NOTICE TO ALL CONTRACTORS:

Official Notice 27-2013: Rehabilitation of the St. Paul Avenue Lift Bridge over the Milwaukee River

This is Addendum No. 2, which provides for the following:

SHEET LS1 OF LS33 – LIFT SPAN FRAMING PLAN

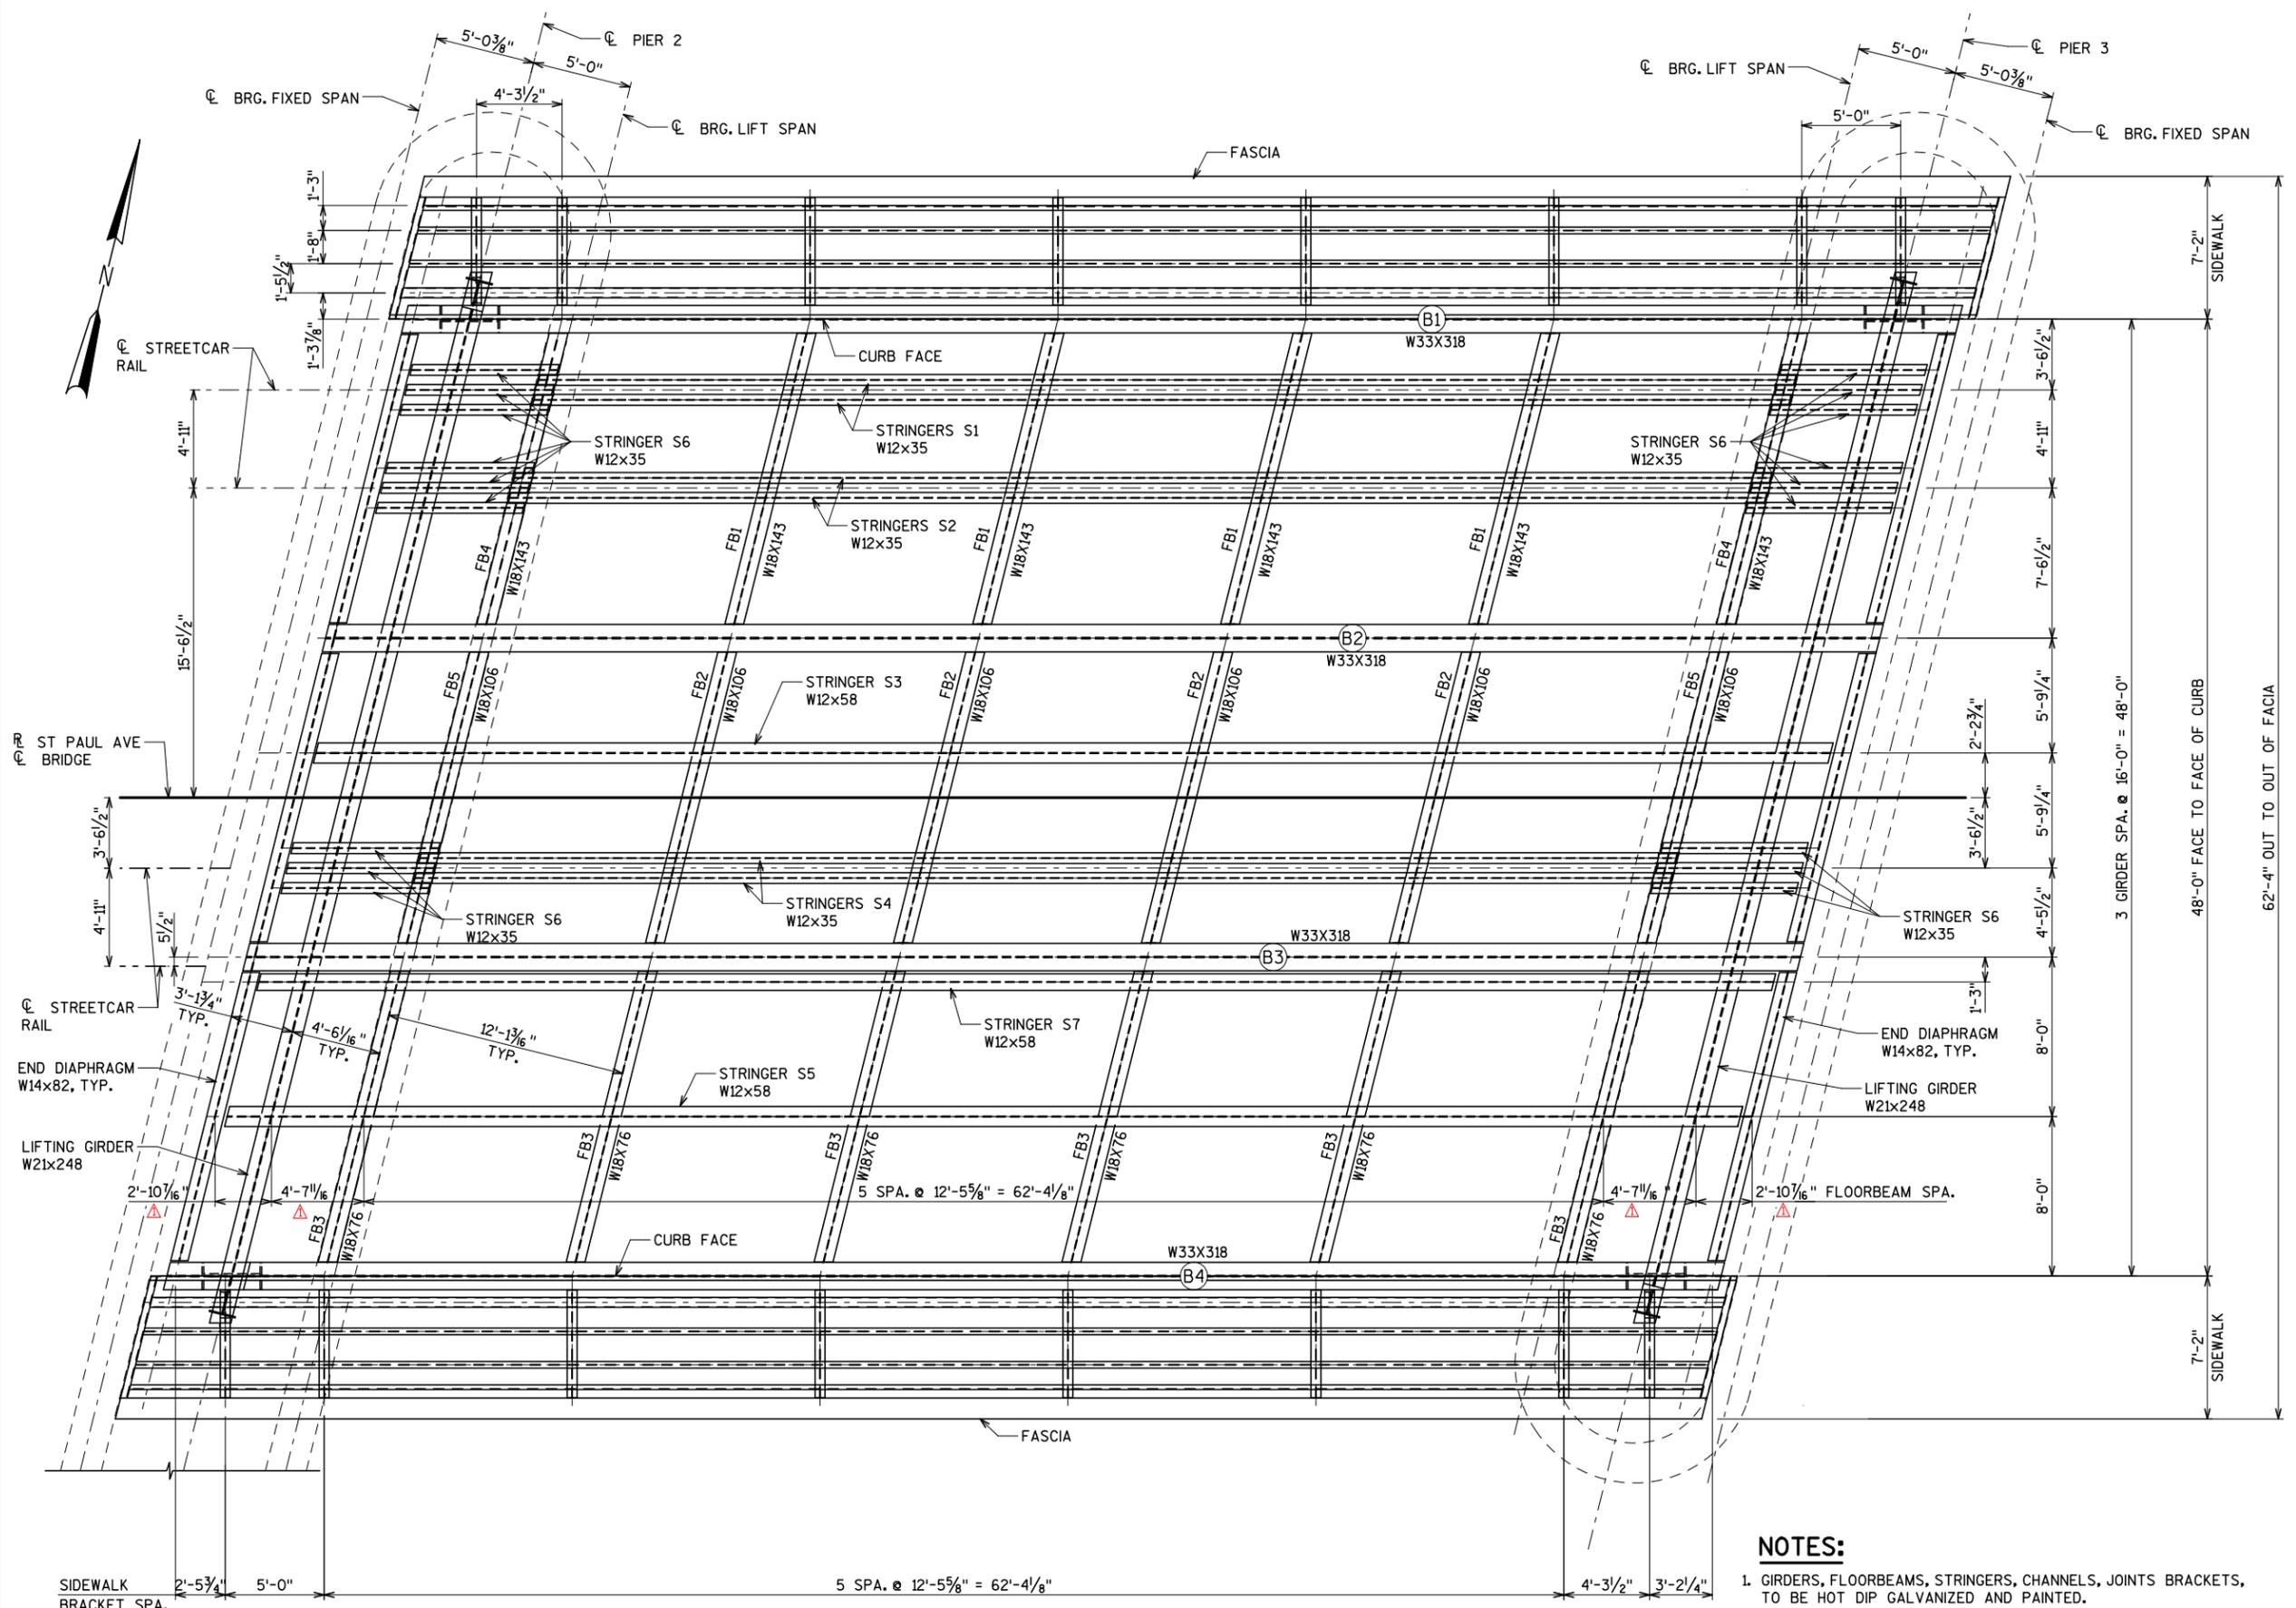
Updated dimensions on “PLAN”

ELEVATION LIFTING GIRDER

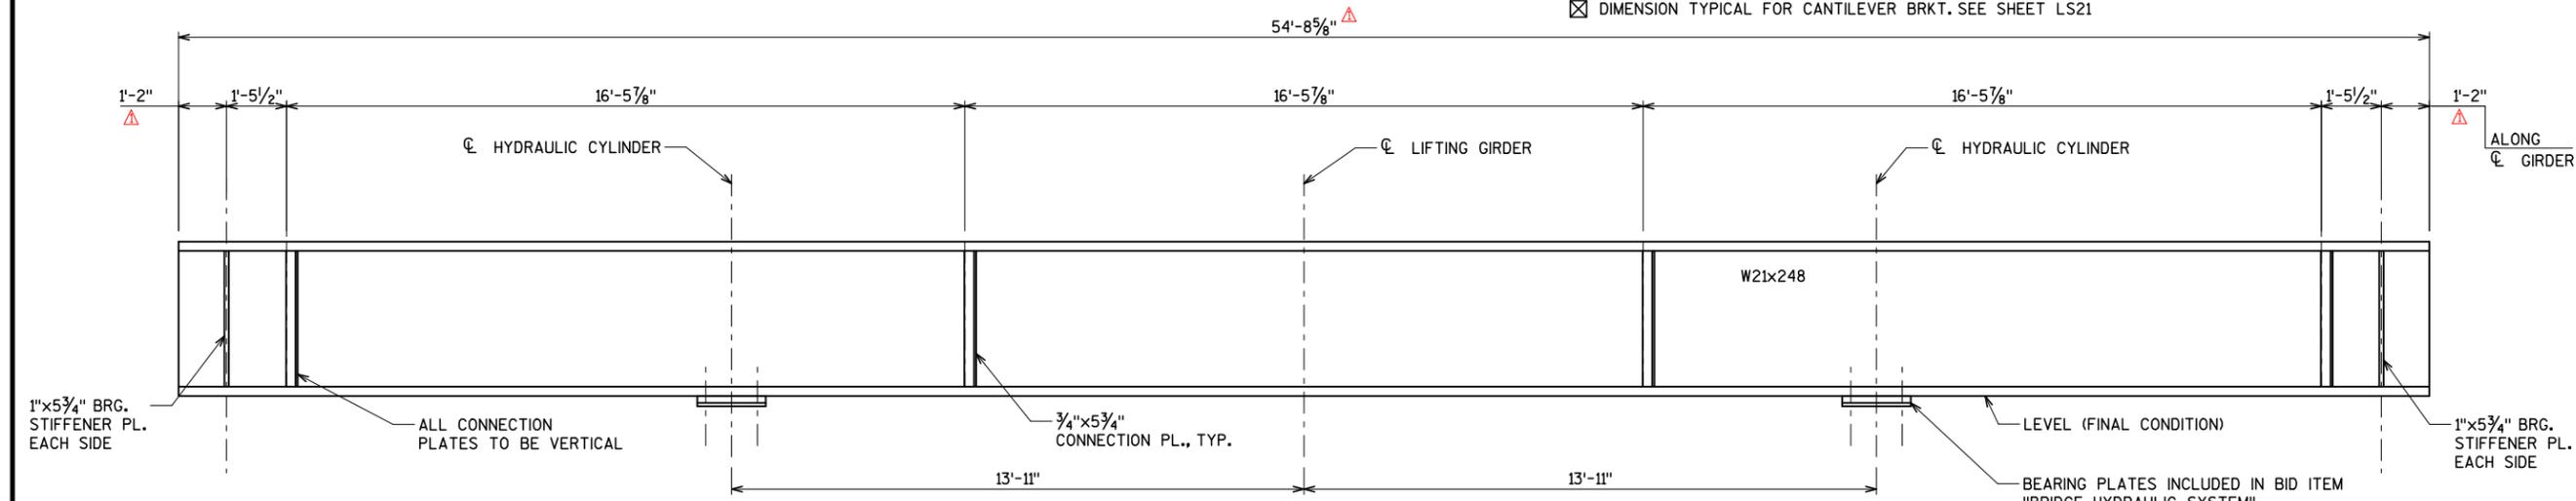
Updated dimensions on “ELEVATION LIFTING GIRDER”

SHEET LS28 OF LS33 – COUNTERWEIGHT

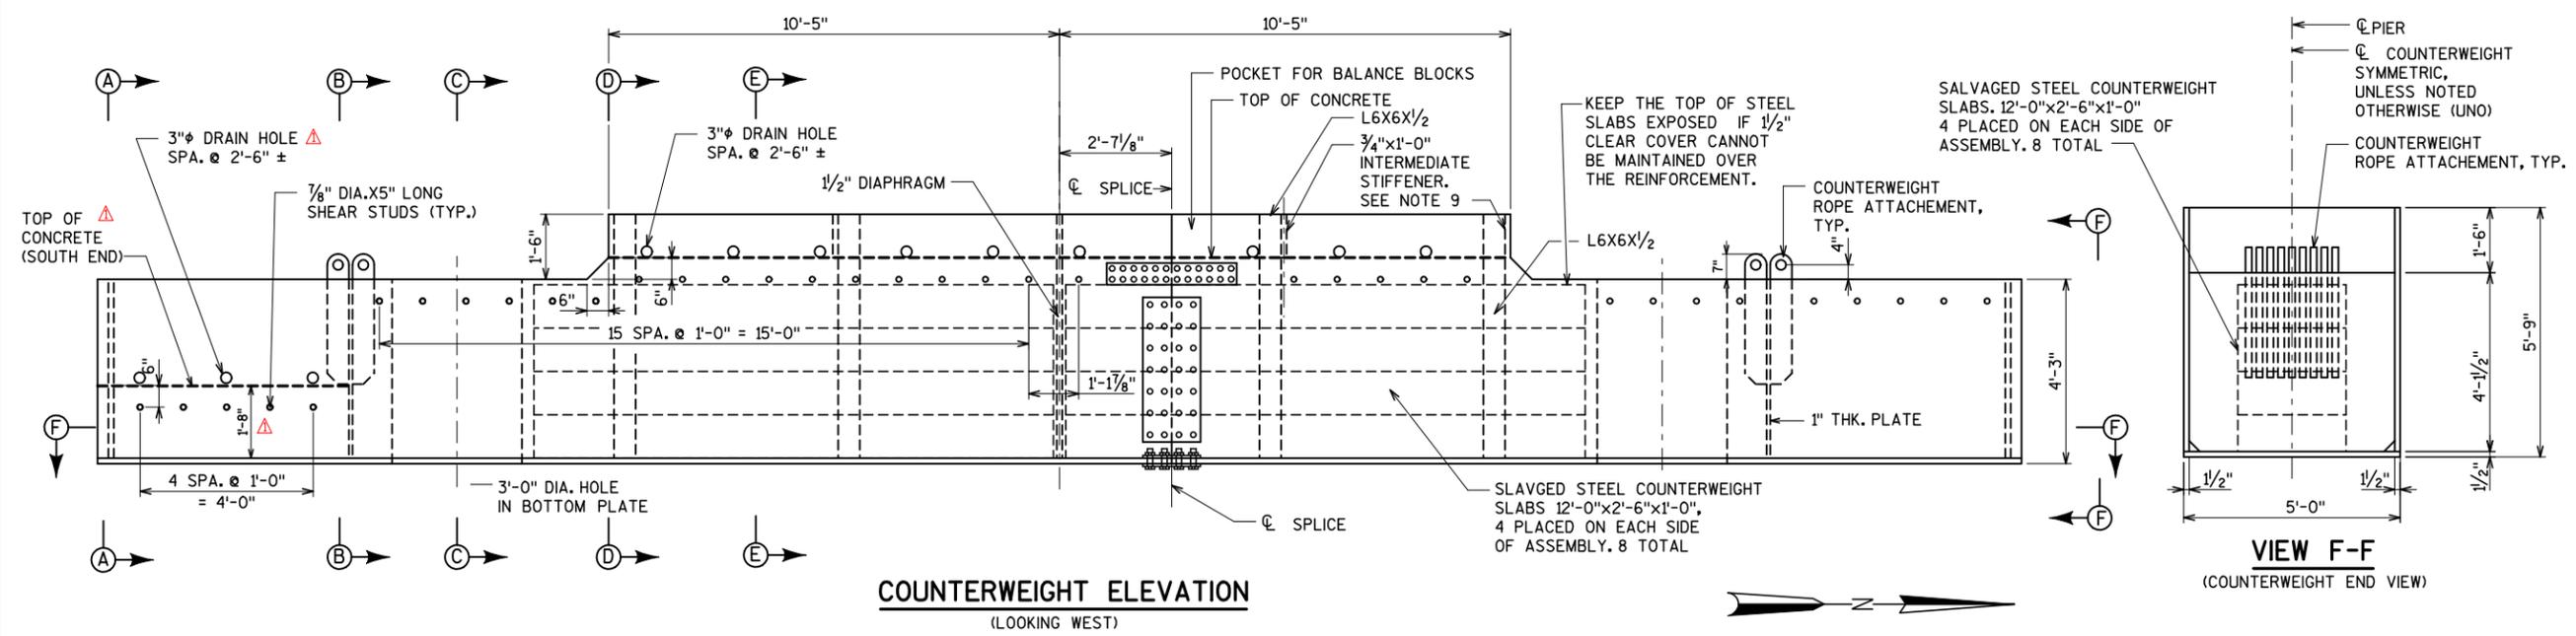
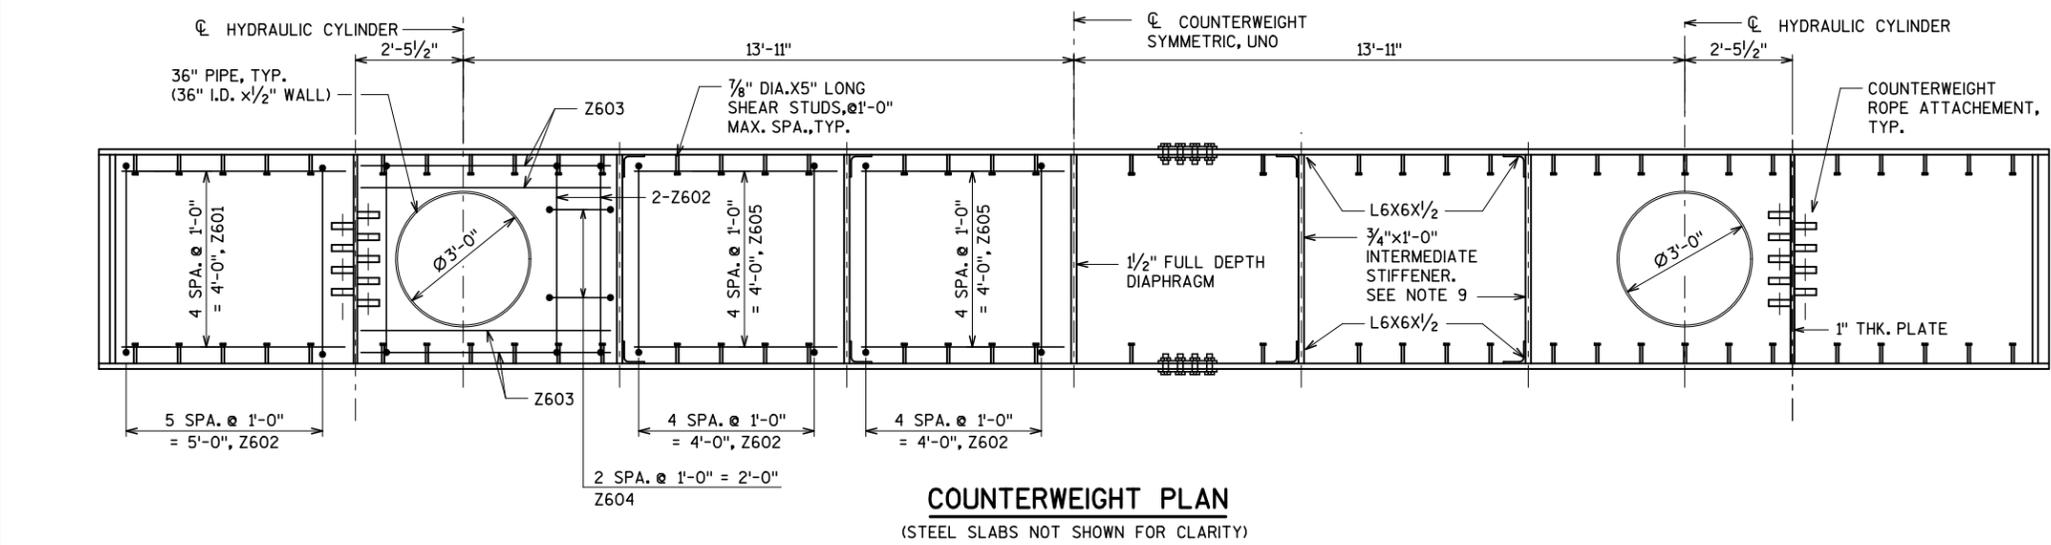
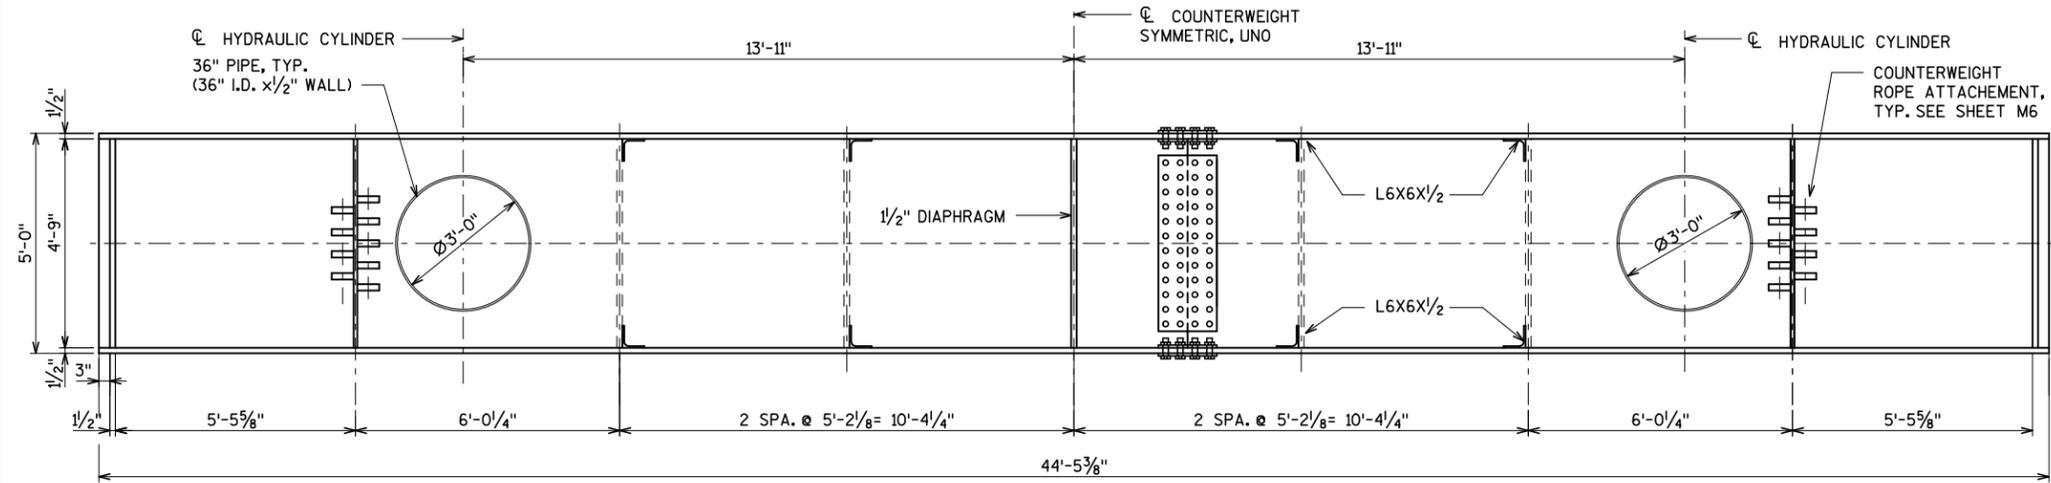
Updated Dimensions and Notes on “COUNTERWEIGHT ELEVATION.”

SHEET LS29 OF LS33 – COUNTERWEIGHT DETAILS

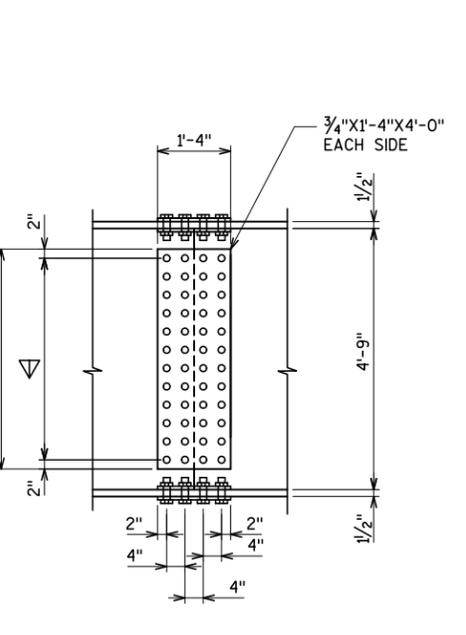
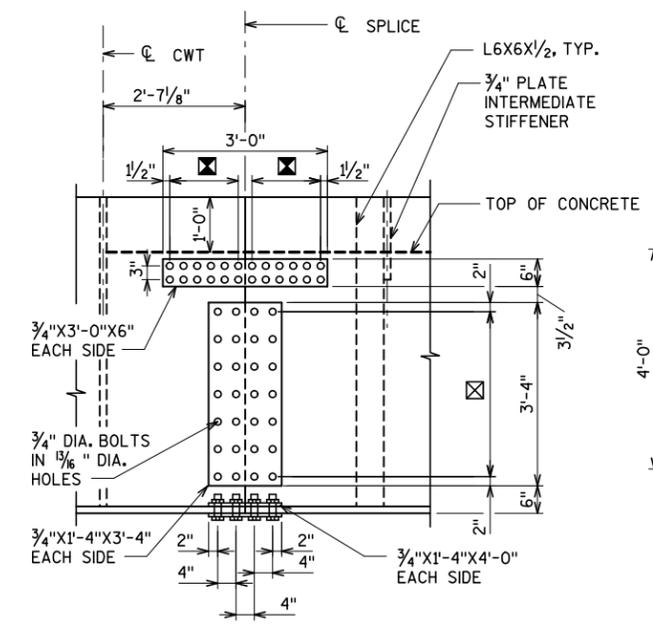
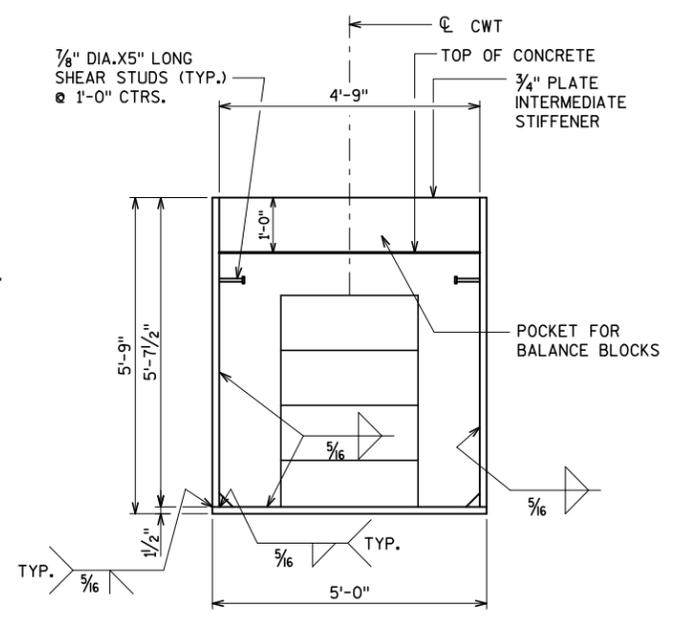
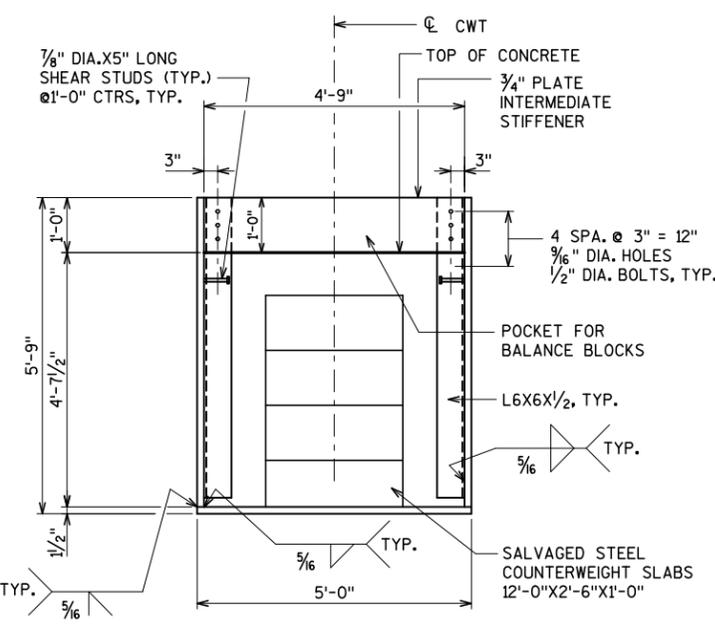
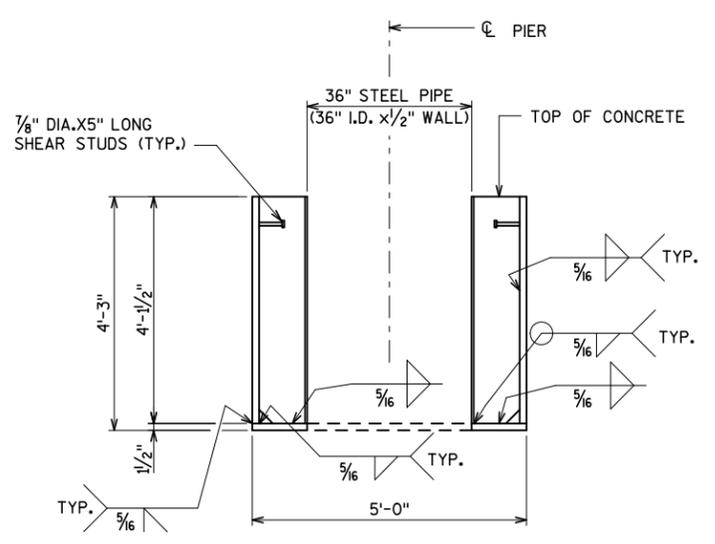
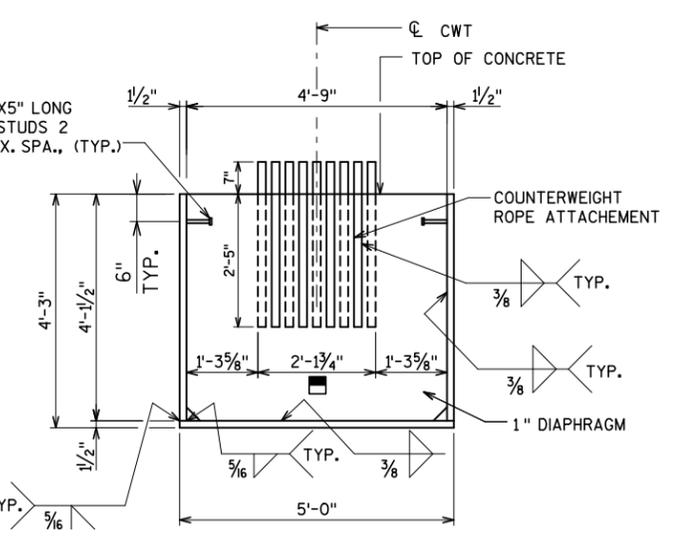
Updated Dimensions and Notes on “SECTION A-A.”
